PROJECT NAME: DIMOVSKI DUPLEXES 2024

PROJECT NUMBER: 2024070025

APPLICATION: MINOR SITE PLAN #31762

REVIEW ITEM: Minor Site Plan

SHEET
 LA-001

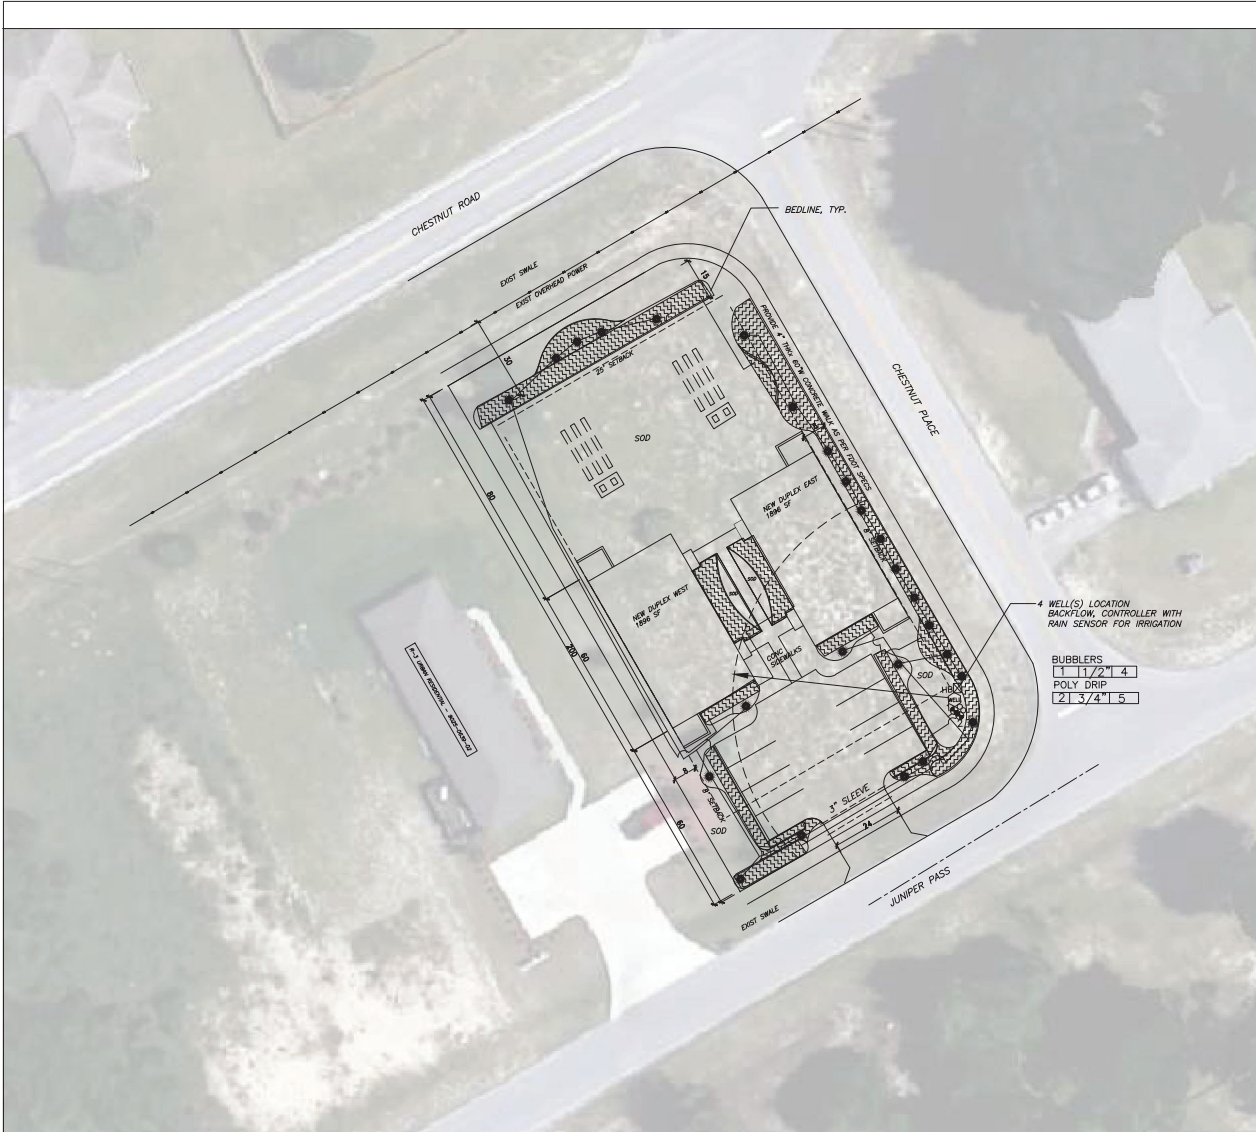
- 13 DEPARTMENT: LSCAPE - LANDSCAPE DESIGN AND IRRIGATION
REVIEW ITEM: 2.12.18 - All trees 10" DBH and larger
STATUS OF REVIEW: NO
REMARKS: Plan states no existing trees, plan also shows two existing trees being preserved - please clarify - 2024 MCPA aerial does not show existing trees

- 14 DEPARTMENT: LSCAPE - LANDSCAPE DESIGN AND IRRIGATION
REVIEW ITEM: 6.7.4 - Shade tree requirements
STATUS OF REVIEW: NO
REMARKS: shade trees to be 3.5" cal. min, plans shows 3"

- 18 DEPARTMENT: LSCAPE - LANDSCAPE DESIGN AND IRRIGATION
REVIEW ITEM: 6.8.6 - Buffers
STATUS OF REVIEW: NO
REMARKS: 1. show required groundcovers in ALL buffers, Liriope is on schedule, show on plan and provide quantity. 2 Waiver required for buffer width reduction for south and east boundaries 3. Show ornamental trees in south buffer 4. area on se boundary is missing buffer, please provide. 5. East and south buffers do not meet 50% planted are requirements

MINOR SITE PLAN
 Scale: 3/32" = 1'-0"

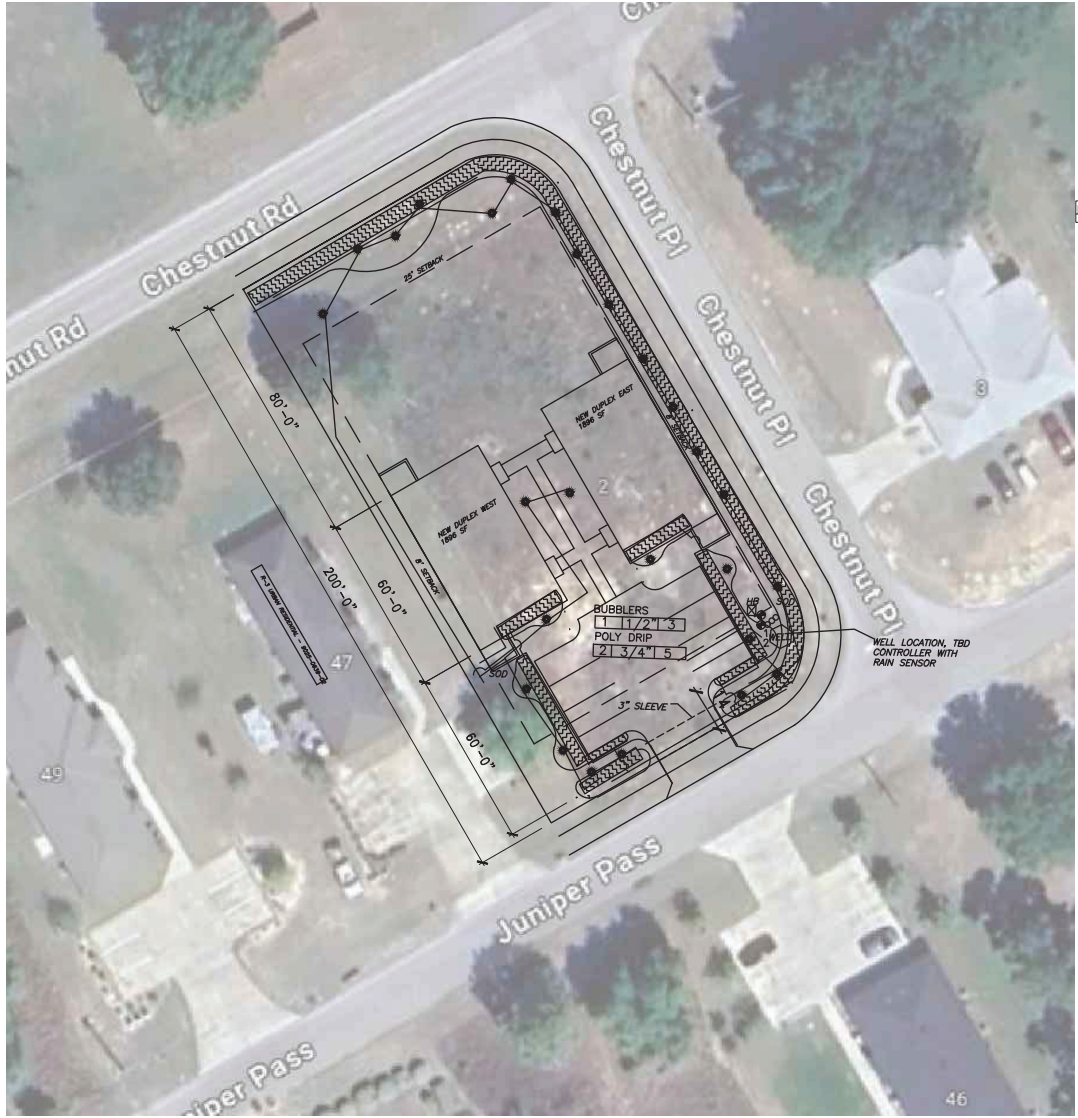
- 9 DEPARTMENT: ZONE - ZONING DEPARTMENT
REVIEW ITEM: 2.12.10- Show any known easements existing or proposed i.e. ingress or egress, landscape, or conservation
STATUS OF REVIEW: INFO
REMARKS: No easements called out.

- 10 DEPARTMENT: ZONE - ZONING DEPARTMENT
REVIEW ITEM: 2.12.27 - Show location of outside storage areas
STATUS OF REVIEW: INFO
REMARKS: None shown

- 11 DEPARTMENT: ZONE - ZONING DEPARTMENT
REVIEW ITEM: 2.12.21/6.3.1.C(10) - Land use and zoning on project and on adjacent properties shown
STATUS OF REVIEW: NO
REMARKS: Please show for subject property and adjacent properties on an aerial of the site and surrounding area.
